MOTORHOME GENERATORS—SHUT OFF WHEN FUEL TANK READS 1/4 FULL	Article No. 02-17-12

FORD: 1999-2003 SUPER DUTY F-53 STRIPPED CHAS.

TSB **98-21-5** is being republished in its entirety to update the model year coverage.

Figure 1 - Article 02-17-12

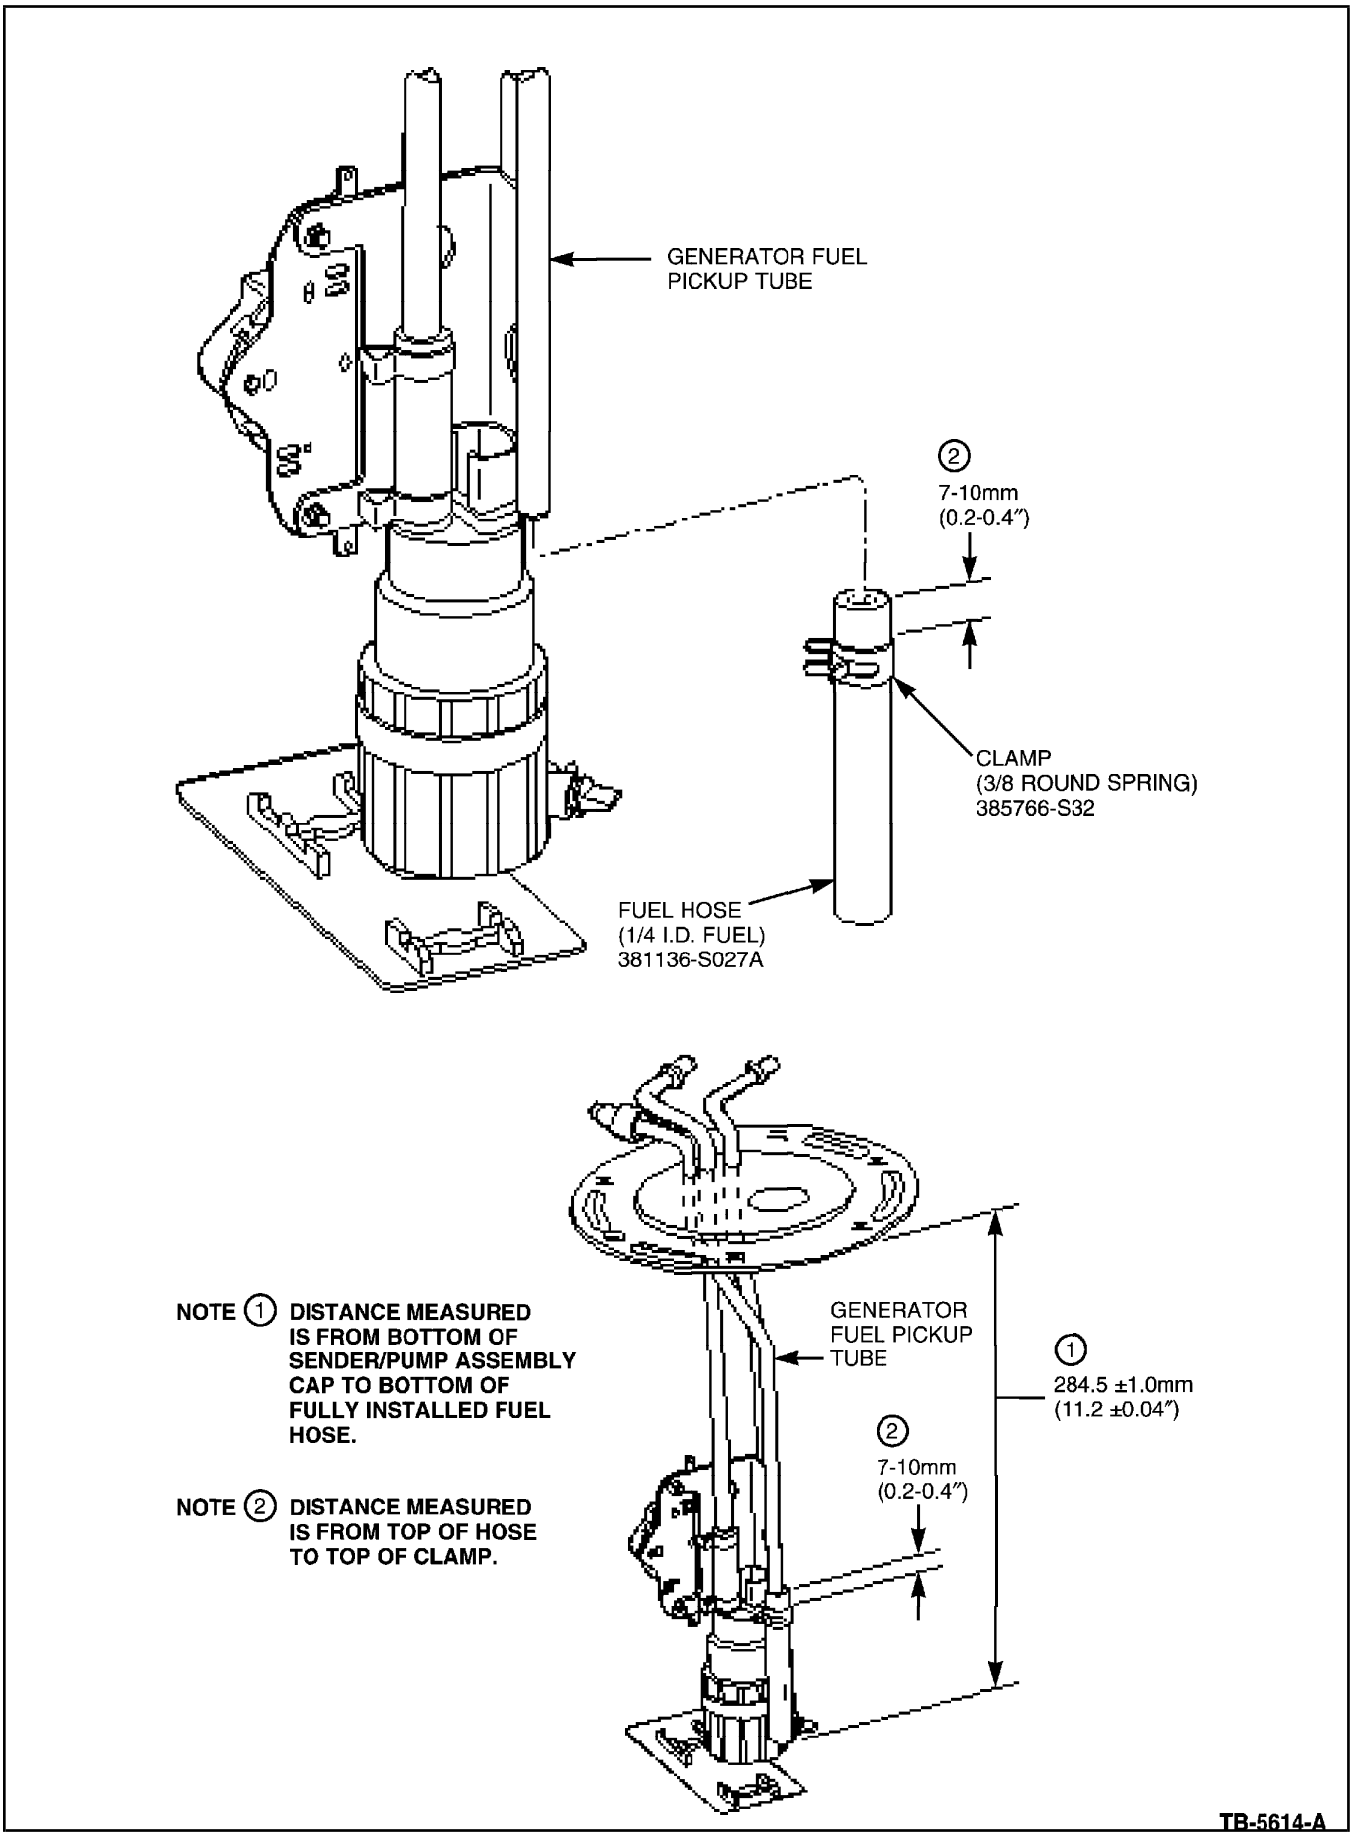
Some motorhome gas powered generators that draw fuel from the chassis fuel tank may shut off before the fuel tank level reaches 1/4 full. This may be caused by the generator fuel pick-up tube (component of fuel pump assembly) not being long enough to draw fuel down to 1/4 full in the chassis fuel tank.

3. Remove the fuel pump and sender from the fuel tank.
4. Install the Fuel Hose (381136-S027A) and Clamp (385766-S32) as shown in Figure 1.
5. Install the fuel pump and sender into the fuel tank with a new O-ring Seal (F6DC-9E275-AA). Ensure that the O-ring is properly seated to prevent fuel leakage. Install and torque the retaining nuts to 8-10 N•m (71-88 lb-in).
6. Install the tank as described in the the F-Super Duty Workshop Manual - Volume II, Section 310-01.

Install a rubber fuel hose extension (381136-S027A) on the generator fuel pick-up tube. The rubber fuel hose extends the generator fuel pick-up tube ensuring fuel supply when the main tank is less than 1/4 full. Refer to the following Service Procedure for details.
